INDESIT company

WITP83IT

F033811

n1040345: Replacement of drum lock button TL EVOII.

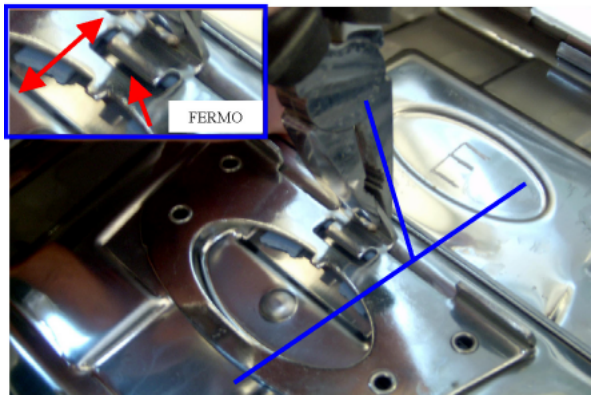
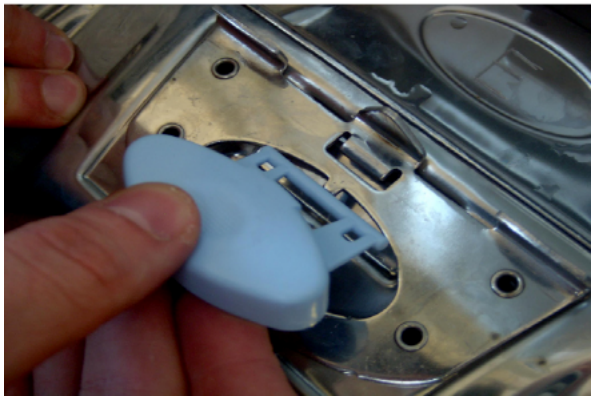
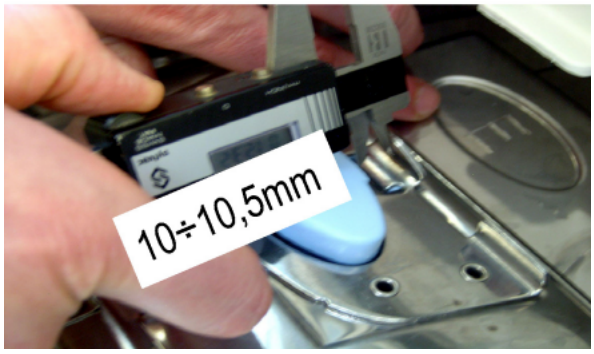
Tools and material needed: pliers, screwdriver, gauge, spring P/N Sat 114989, button P/N Sat 114990.

1) turn the central tip of the catch in the direction shown (FIG.1);

2) bring the tip to a vertical position and ensure that the broken button is disengaged from the catch restraint and can be removed (FIG.2);

3) remove the remaining part of the button with the aid of a screwdriver, taking care not to scratch the doors (FIG.3);

4) pre-assemble spring to button (FIG.4);

5) insert button between catch and door (FIG.5);

6) bring the button into position and arrange the spring in its location in the door (FIG.6);

7) turn the central tip of the catch in the direction shown to return it to its starting position (FIG.7);

8) check the distance between button and catch (FIG.8);

9) check correct operation of the button when opening and closing the doors (slight inclination errors of the catch can result in faulty closing of the doors) (FIG.9).

n1040382: Drain pump with bayonet-style filter - top Loading Brembate

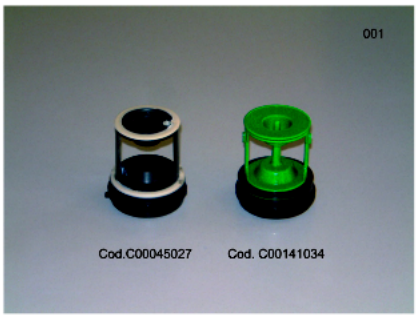
From serial no. 51021.0001 a new drain pump with bayonet-style filter has been installed on all top loading washing machines manufactured in Brembate.

New parts:
C00141862 - Drain pump
C00141034 - Pump filter kit

Premodification parts:
C00111409 - Drain pump
C00045027 - Pump filter kit

The new parts can be used instead of premodification ones.

N1040404FIG1

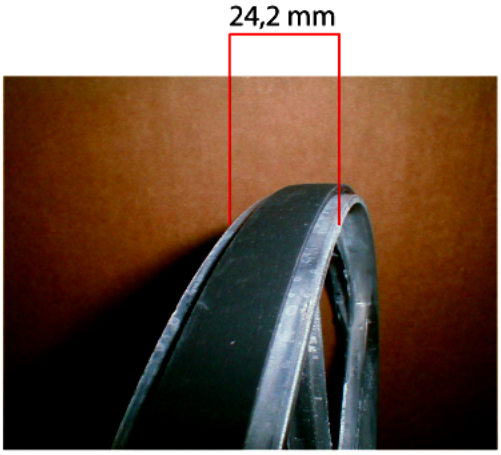
n1040404: New pulley installed on top loading washing machines up to 1000RPM (NO tub lock)

From serial no. 51202.0001 the pulley track has been widened from 21.2mm to 24.2mm (see picture N1040404FIG1).

new pulley
C00142832 - D280 24.2 mm track

Premodification pulley
C00083912 - D280 21.2 mm track

The new pulley can also be used on premodification versions of the models referred to in this release.
